N4010A-08B

S E R V I C E N O T E

N4010A Wireless Connectivity Test Set

RF Assembly Reliability Issue

Figure 3

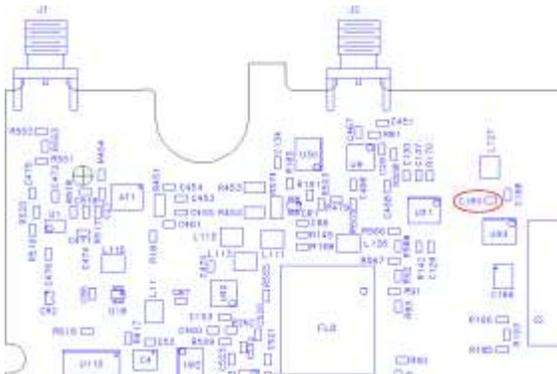
- (c) Refer to Figures 3 and 4:
Locate capacitor C160, and check to see if it is burned-out. If it is burned-out then the complete RF Assembly must be replaced (part number N4010-69870). If it is not burned out then proceed to step 2(e).

Figure 5

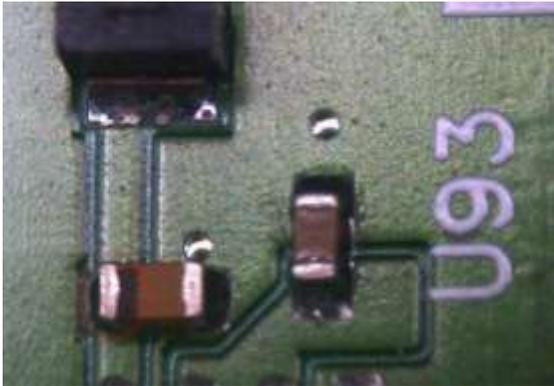
- (e) The polarity of C160 is indicated by a dark brown stripe at the positive electrode. The correct orientation of C160 is shown in Figure 5, whilst Figure 6 shows the wrong orientation of C160. If the orientation of C160 is correct, then proceed to step 2(h), otherwise continue to step 2(f).

Figure 9

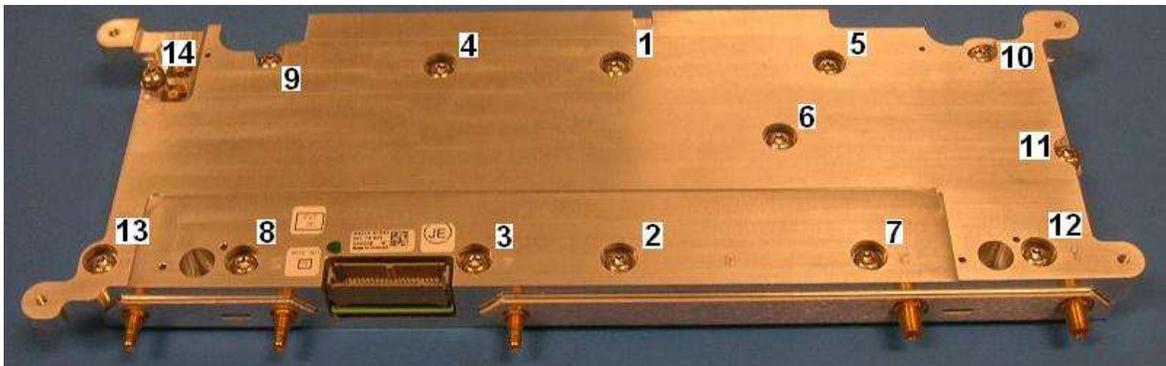
- (h) Place the metal gaskets on the PCB, ensuring the position and orientation of each one is correct. Carefully fit the top half of the RF shield, and tighten the 14 screws to 21 in-lbs (2.37 Nm) using the sequence shown in Figure 9.

Note: Repeat the tightening process once more to ensure the RF gasket is fully compressed.
